REMARKS

Appl. No. 10/662,267
Amdt. Dated August 5, 2004
Reply to Office Action
Annotated Sheet

Fig. 3

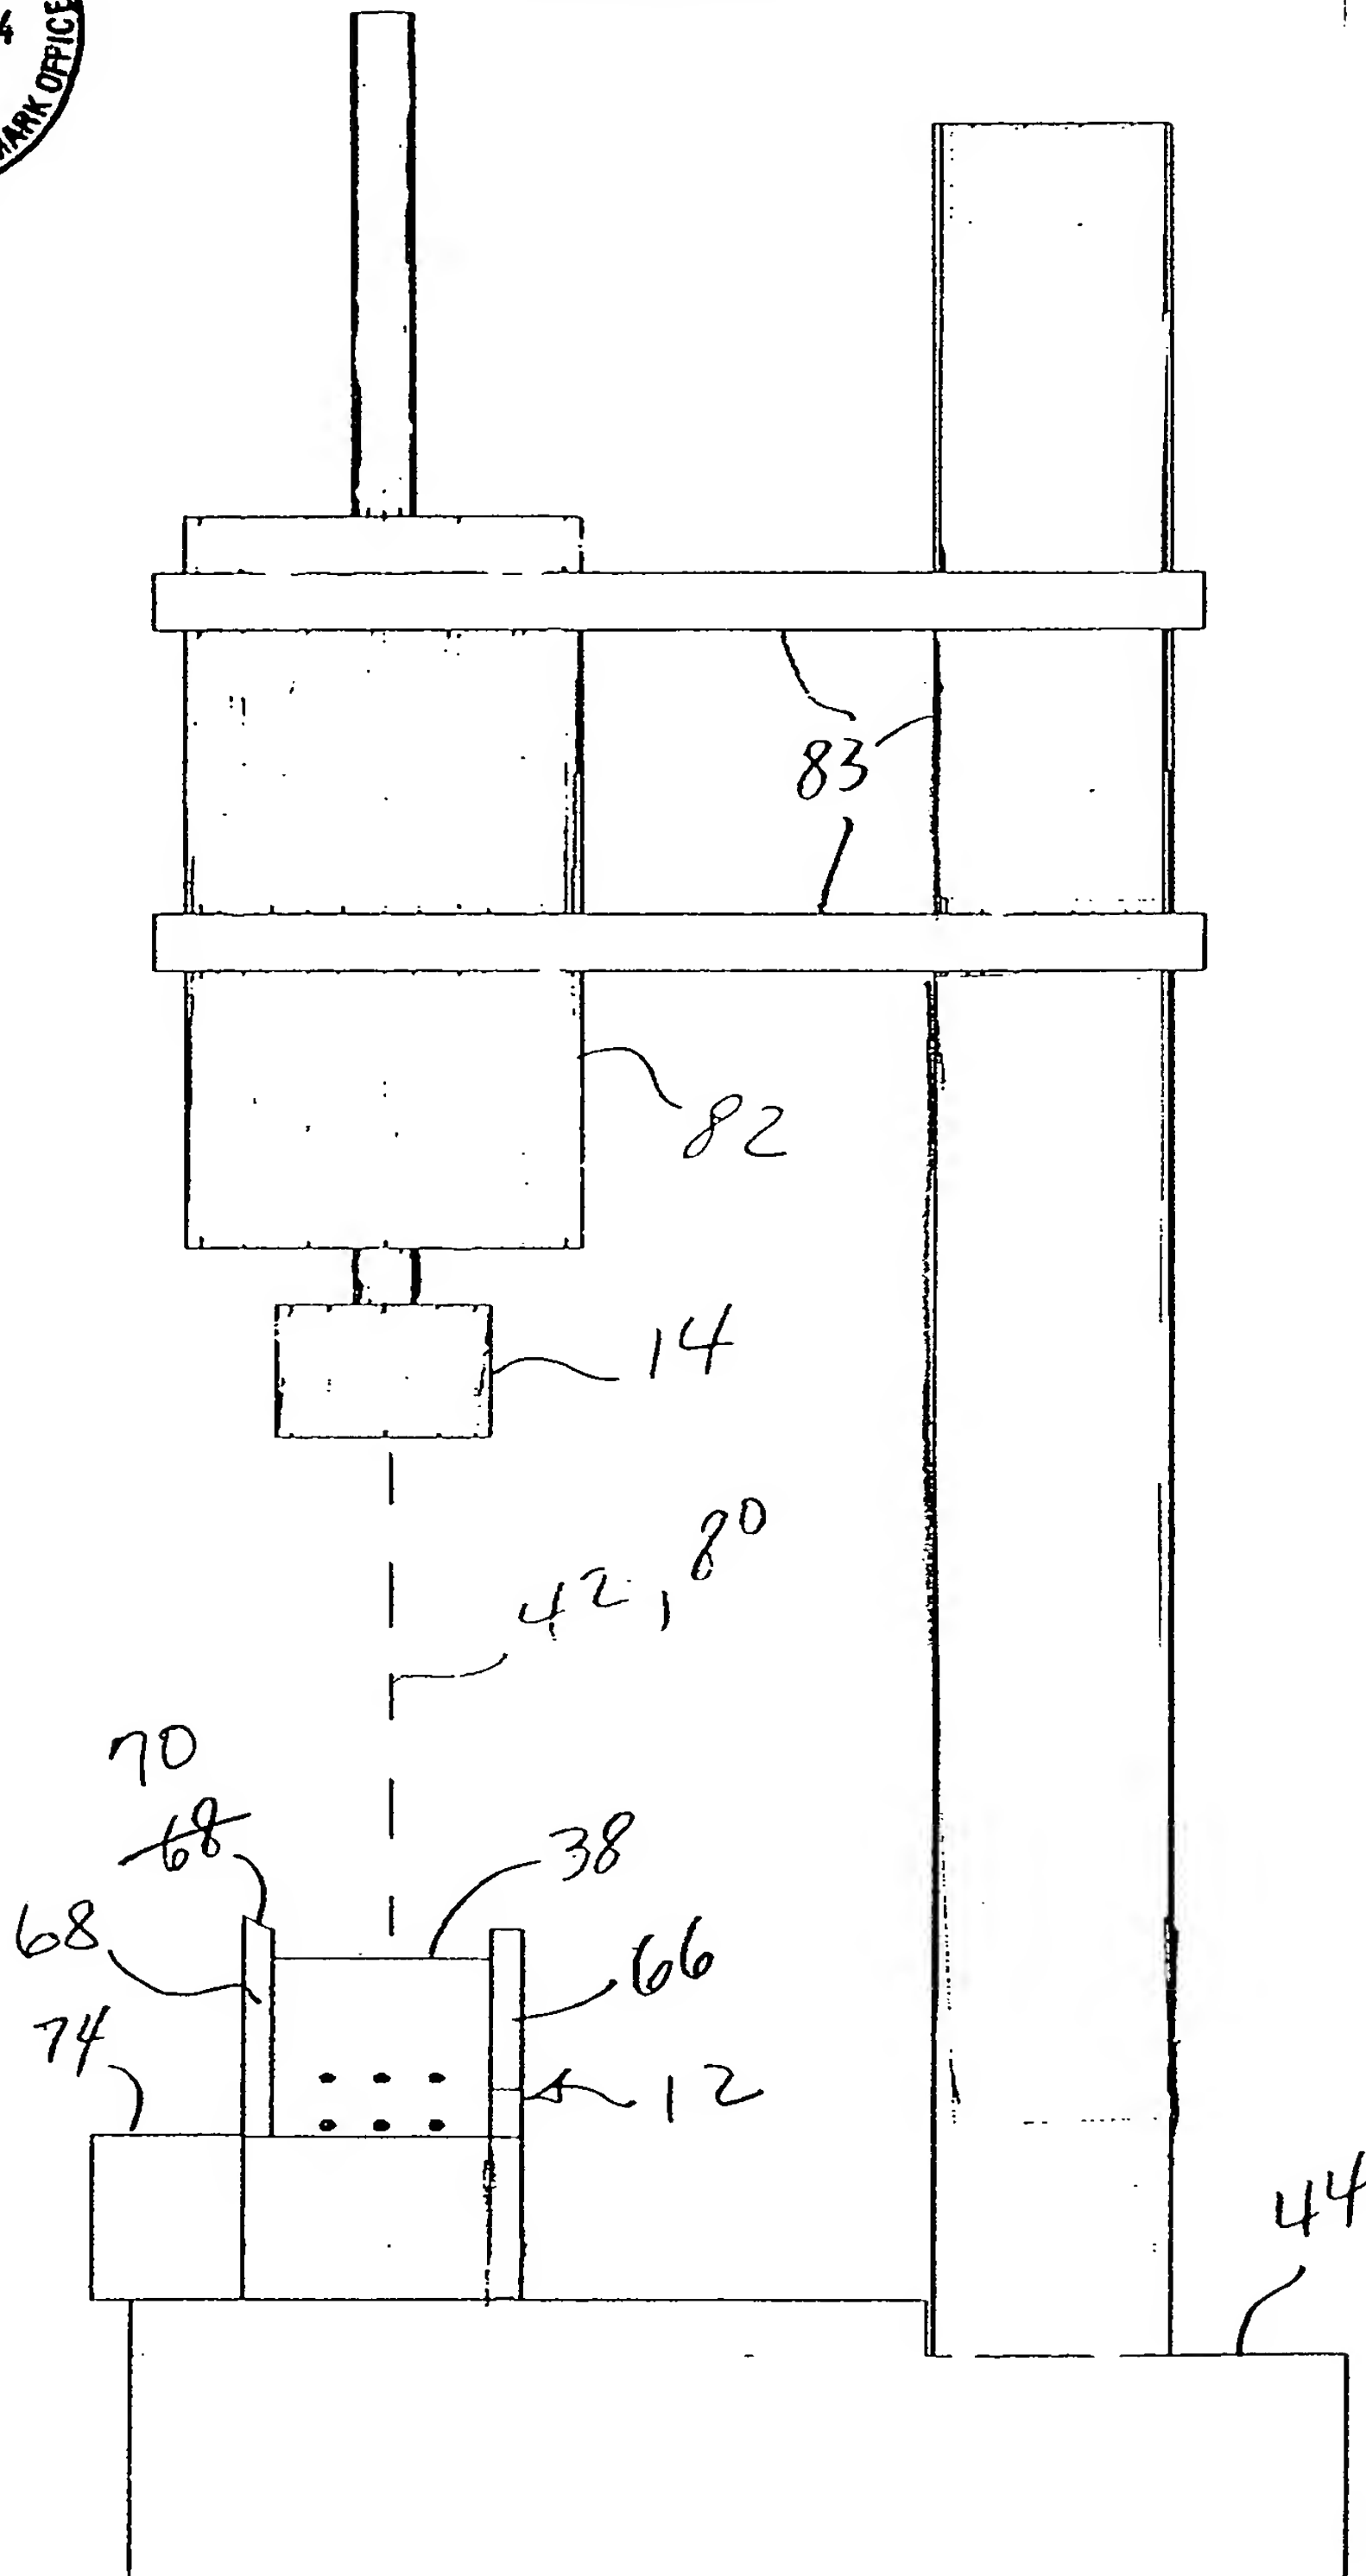
The rejection of Claims 15-33 under 35-USC-112, first paragraph, has been noted. Applicant's attorney has carefully reviewed the disclosure and has amended Figs. 3-5 by placing reference numerals in correct correlation to the description set forth in the original specification. In so doing, there is now a clear description of the invention that is more than sufficient to enable one of ordinary skill in the art to practice the invention. Applicant's attorney regrets the confusion caused by the reference numerals as filed, and submits that no new material has been added.

Fig. 8

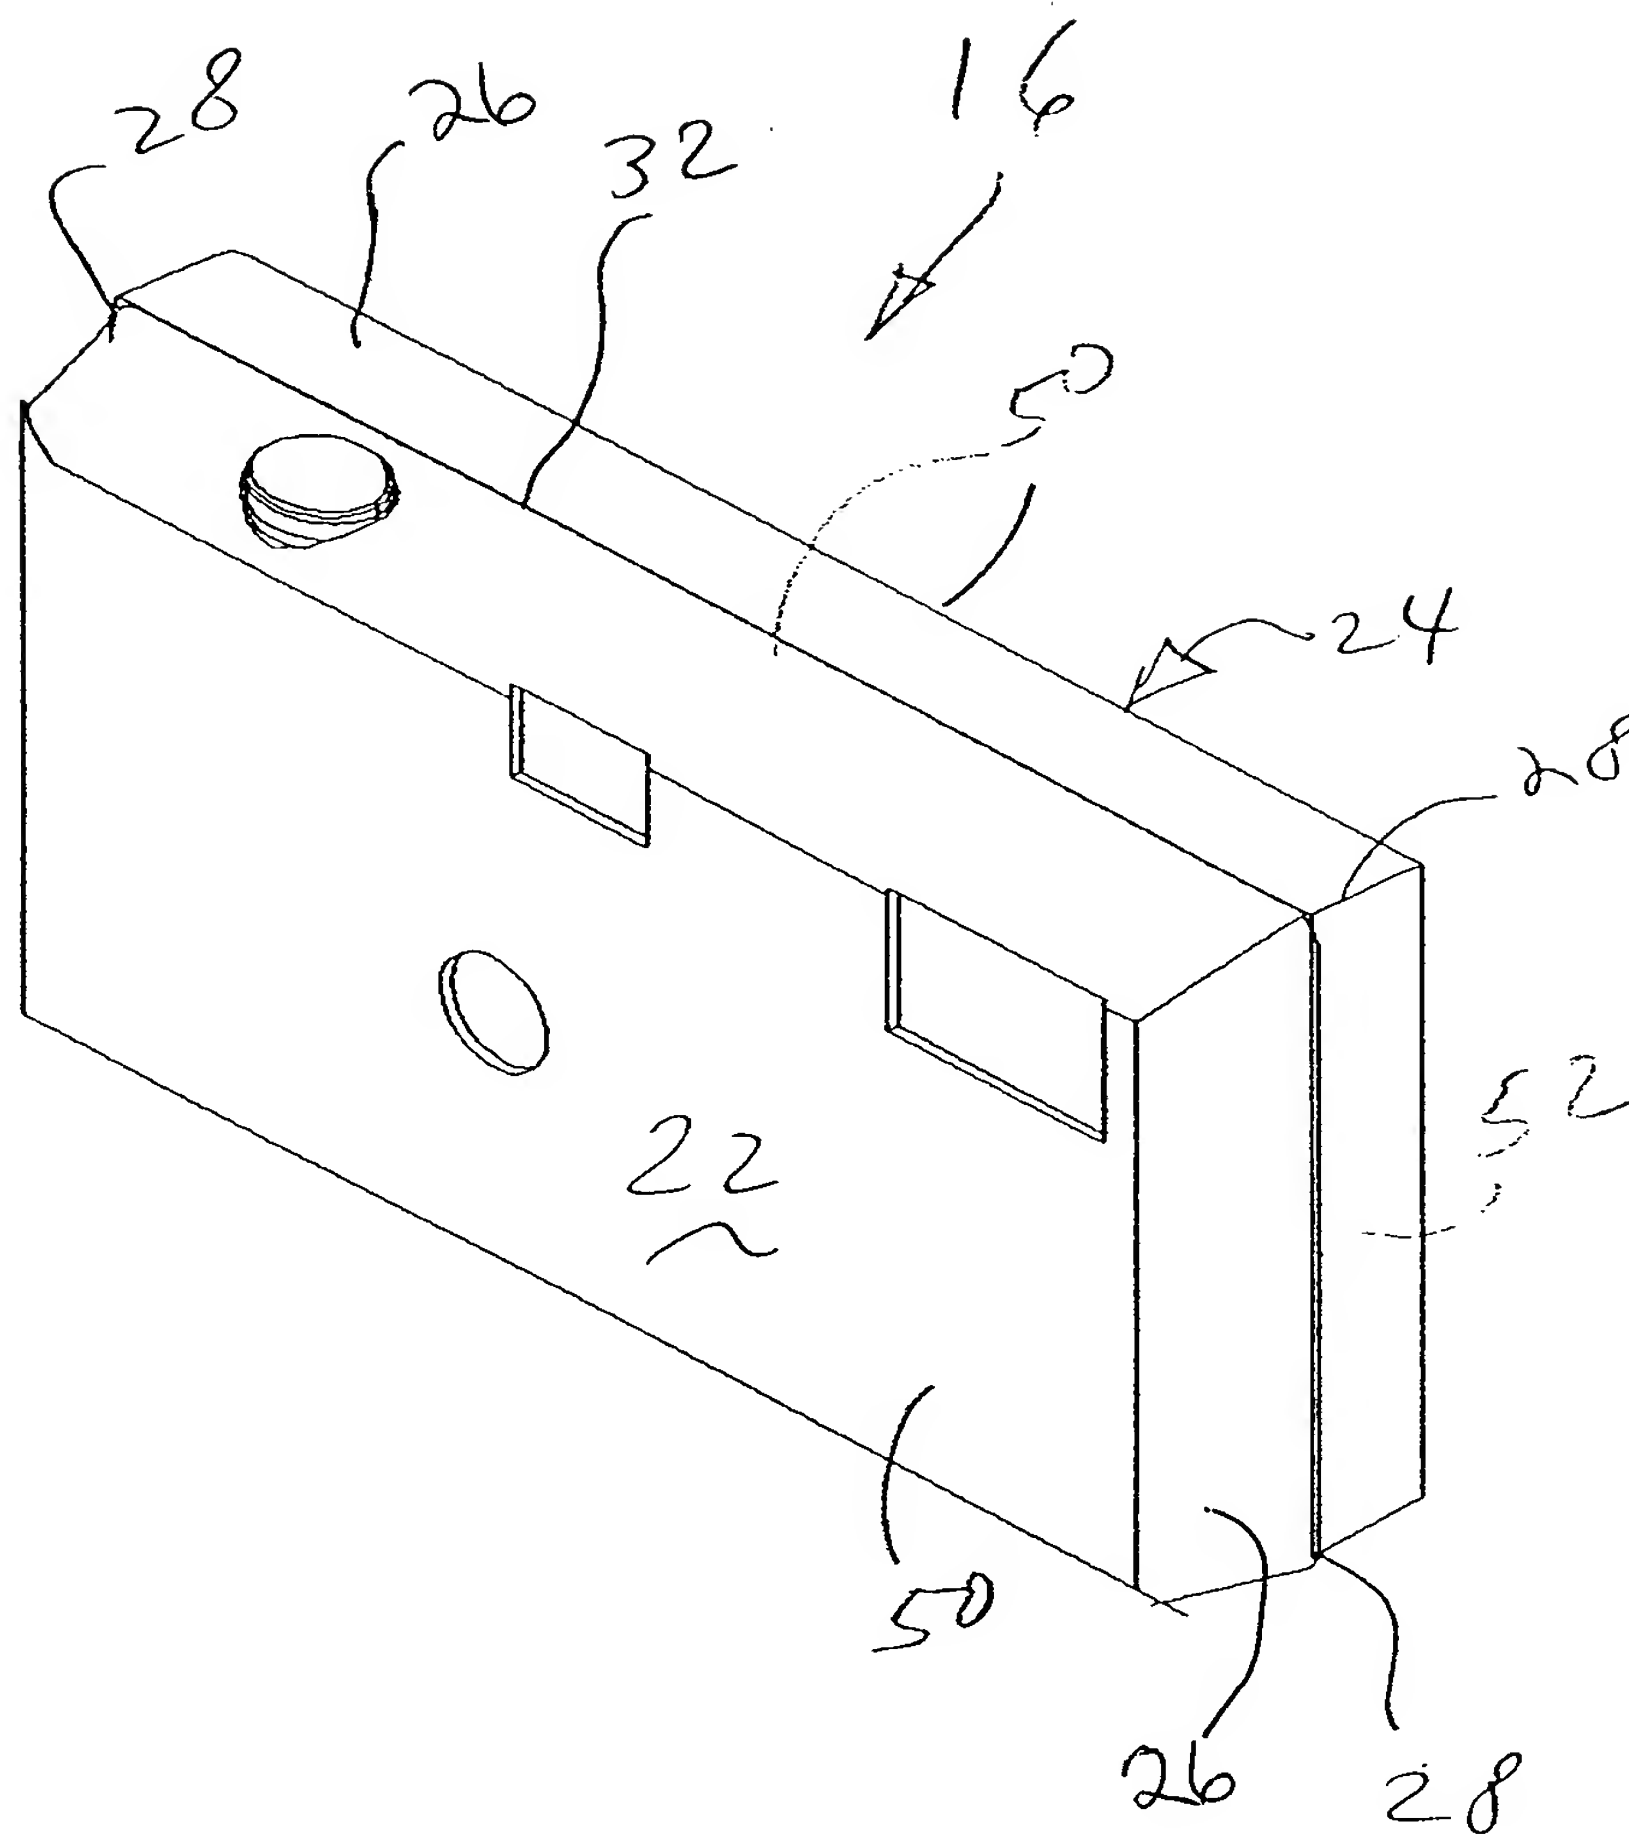
The Examiner's objection to the Drawing has been noted, and the missing reference numeral "26" has been added to FIG. 8. No new matter is added.
